City of Mississauga Department Comments

Date Finalized: 2023-03-22 File(s): A49.23
Ward: 2

Property Address: 1333 Clarkson Rd N

Appendix 1 – Transportation and Works Comments

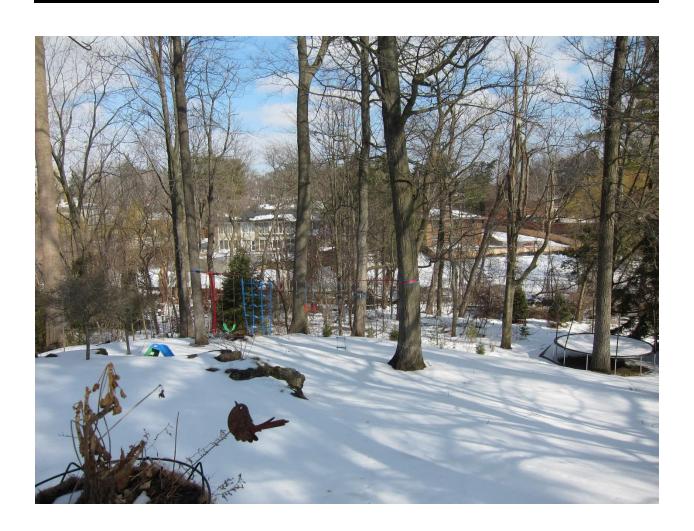
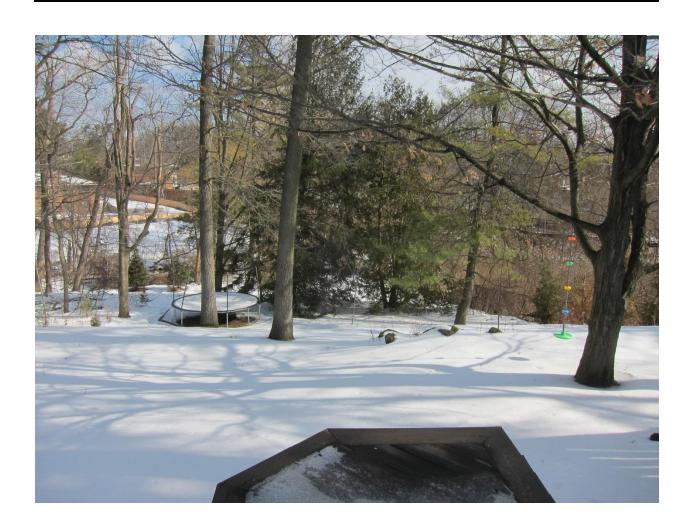
We are noting for Committee's information that any Transportation and Works Department drainage related concerns/requirements for the proposed addition and pool will be addressed by our Development Construction Section through the future Building Permit process.
